Bug Fix for sampled pulse used for quantization

COM Commit Request Number 4p9_7

Adam Gregory, Samtec

Off-by-one fix (comparison plot)

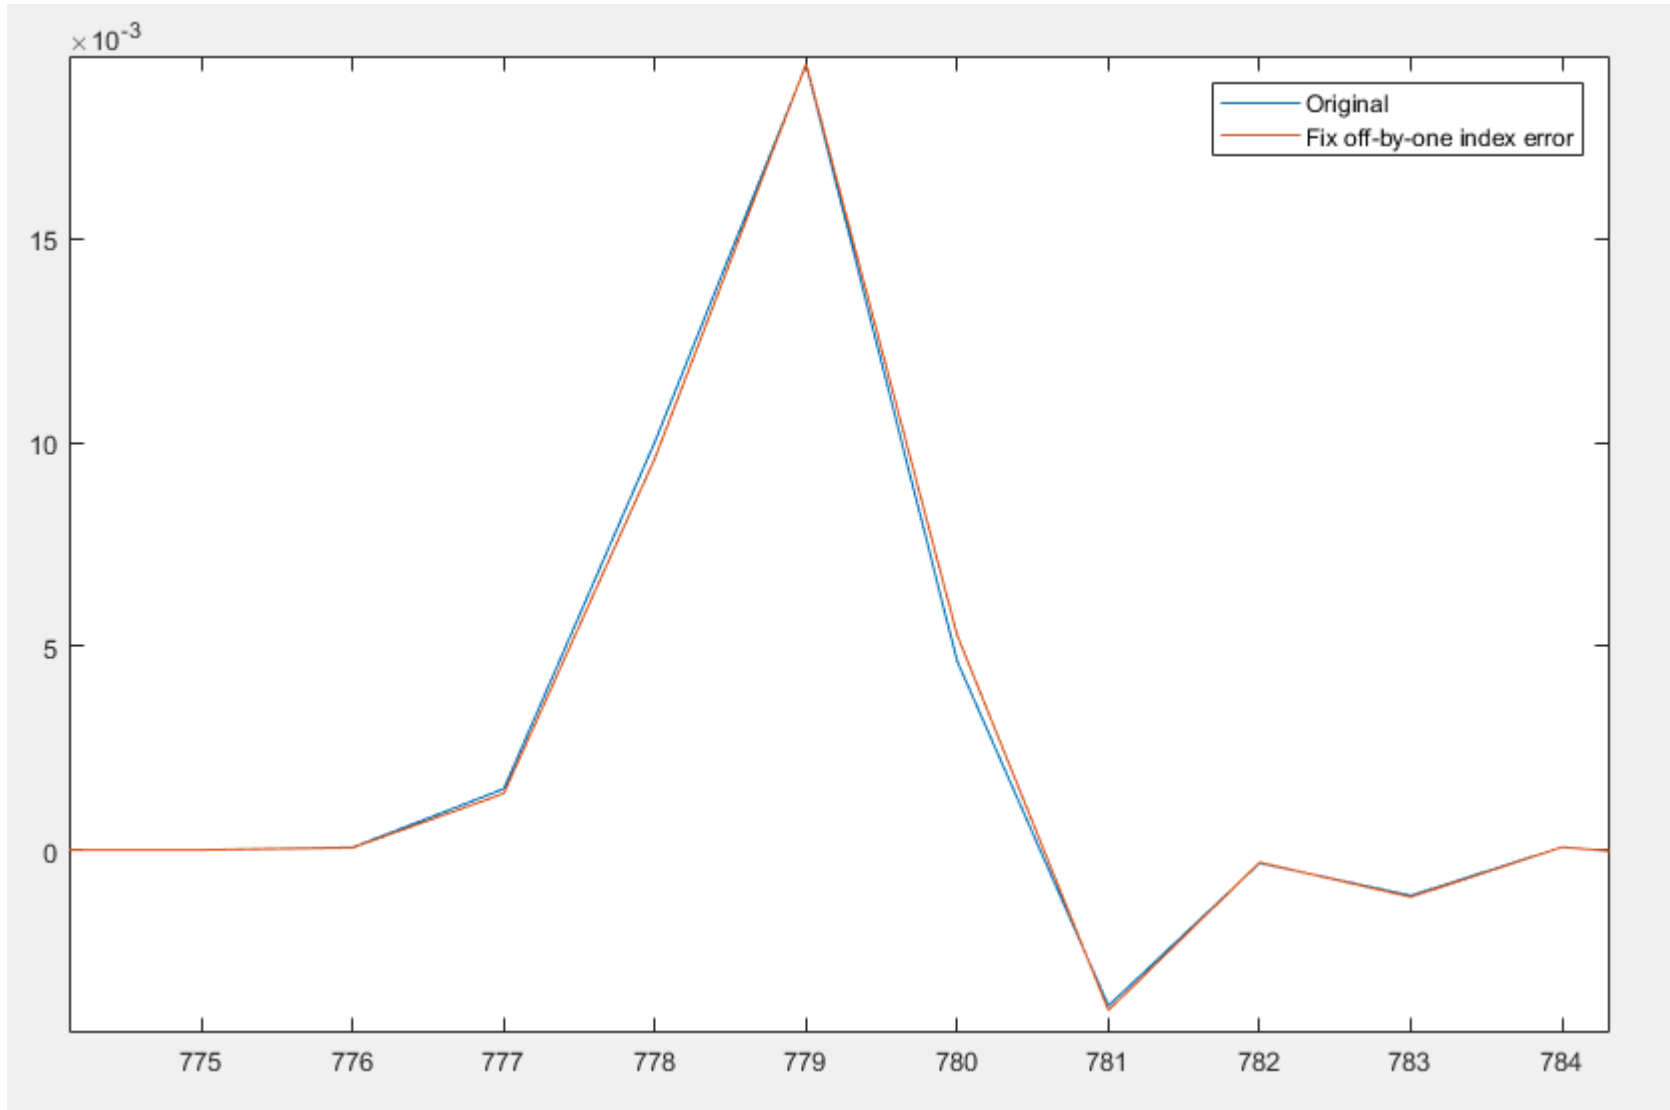
- `pulse_sampled_w_tx_ffe_ctle` is created in `Apply_EQ`
- It is used to calculate quantization noise that is used for the final COM noise PDF
- This update fixes an off-by-one indexing bug when sampling the pulse response
- Impact:
 - In limited testing, observed less than 0.05dB COM change from the bug fix. It is unknown if there are channels that would show meaningful COM change.

- Red is removed line. Green is added line.
- The original code resulted in missing the cursor by one index.

```
src/Apply_EQ.m
...    @@ -85,7 +85,7 @@ for i=1:param.number_of_s4p_files
85    85    % Next 4 lines determine a pulse response required quantization,
86    86    % at the CTLE output with Tx_ffe
87    87    chdata(i).ctle_pulse = eq_pulse;
88    -    [~, sample_start] = min(abs(chdata(i).t-fom_result.sampled_best_sbr_precursors_t(1)));
88    +    sample_start = mod(fom_result.t_s-1, param.samples_per_ui)+1;
89    89    chdata(i).pulse_sampled_w_tx_ffe_ctle = eq_pulse(sample_start:param.samples_per_ui:end);
90    90    chdata(i).t_sampled_w_tx_ffe_ctle = chdata(i).t(sample_start:param.samples_per_ui:end);
91    91
...    ...
```
